T1250A-03

Modification Recommended Service Note

T1250A Smart RF Switching Unit

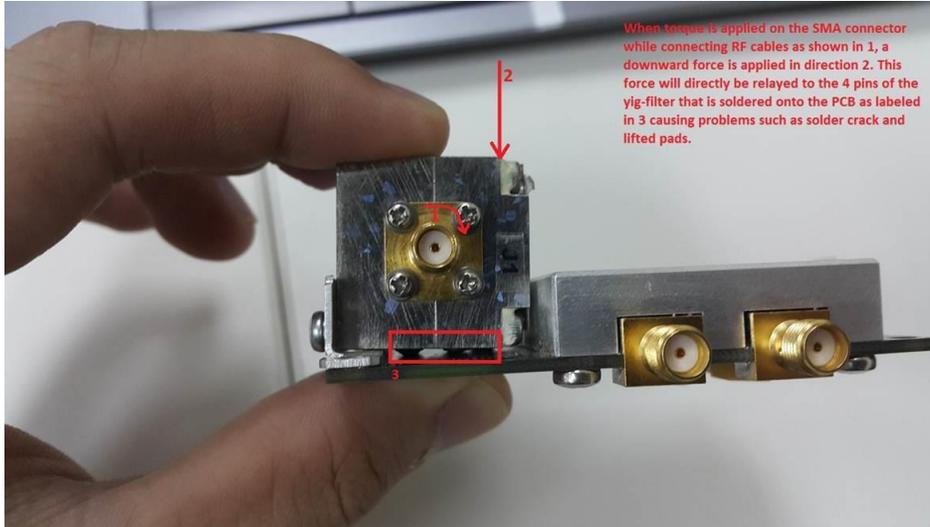
A careful inspection of the YIG filter module PCB of failing units revealed solder cracks in the YIG filter pins:

Root Cause analysis determined two possible sources for this problem:

- 1- At factory assembly stage, an RF cable was attached to the YIG filter, before the metal plate that attaches the YIG filter to the PCB was properly attached to the PCB. That torque may cause the solder cracks. This is the most probable cause.

- 2- After assembly, although the YIG filter is attached to the PCB with the metal plate, there is some free space between the bottom side of the YIG filter and the PCB, thus allowing vibrations to be transmitted to the YIG pins soldering points.

Side View:

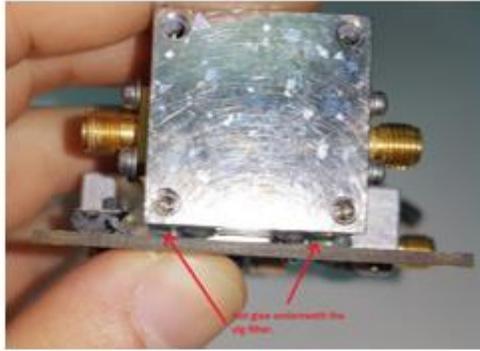
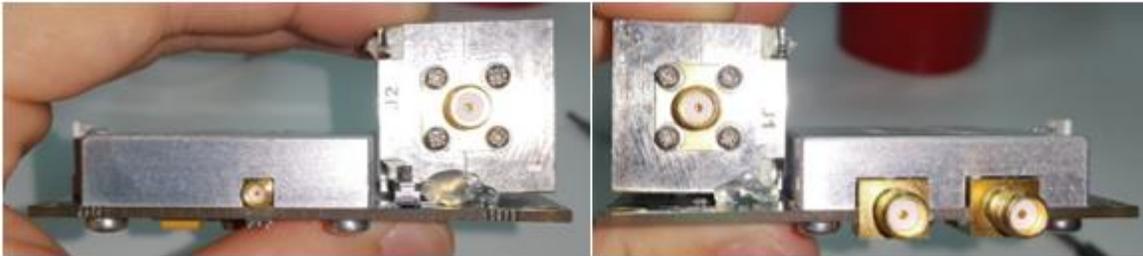
- 1- A change was immediately included in the Assembly procedure. The RF cable must be connected after the YIG module has been installed in the T1250A chassis, so that the YIG filter pins are not forced during assembly stage.
- 2- A design change was defined:
 - Short term solution: add hot glue between the component and the PCB, as it is shown in the following pictures:

This change has been implemented in production starting from MY54050159. In Return to Factory repairs, it has been incorporated in November 2015 (it has been included as a standard check for T1250A RTF process). To current date, these are the modified existing units:

New bracket design

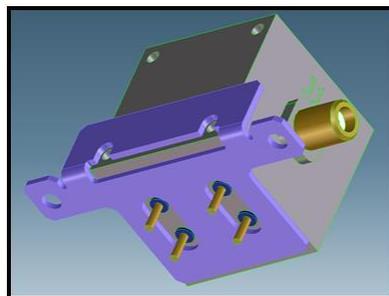
- Long term solution: change the bracket that attaches the YIG filter to the PCB. This design change will be put in Production in FY16, once the current stock of YIG filter subassemblies is depleted (to avoid desoldering the YIG filter which could potentially damage the component).

The following picture shows the YIG filters location:

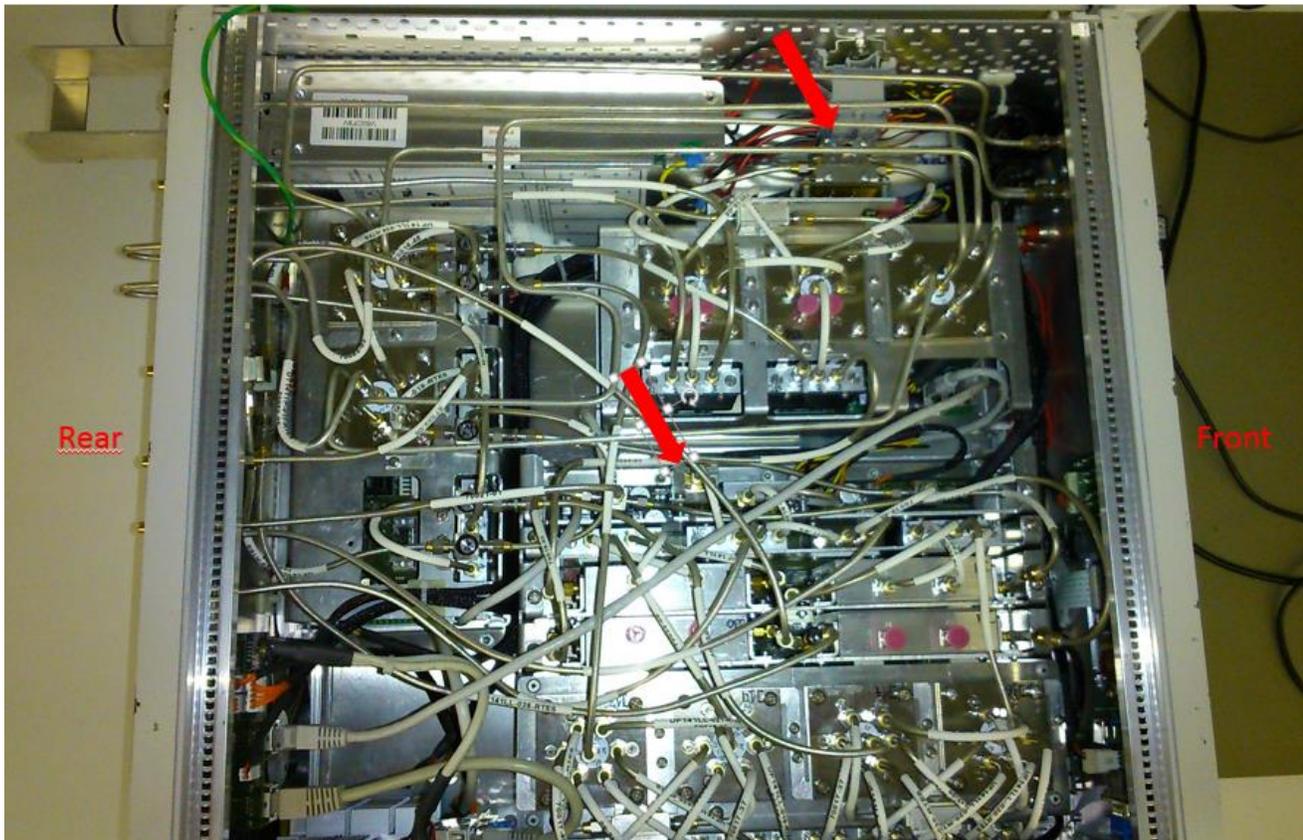
Hot glue fix can be easily inspected by removing the top cover of the instrument, but the PCB inspection can only be done if the YIG module is disassembled.
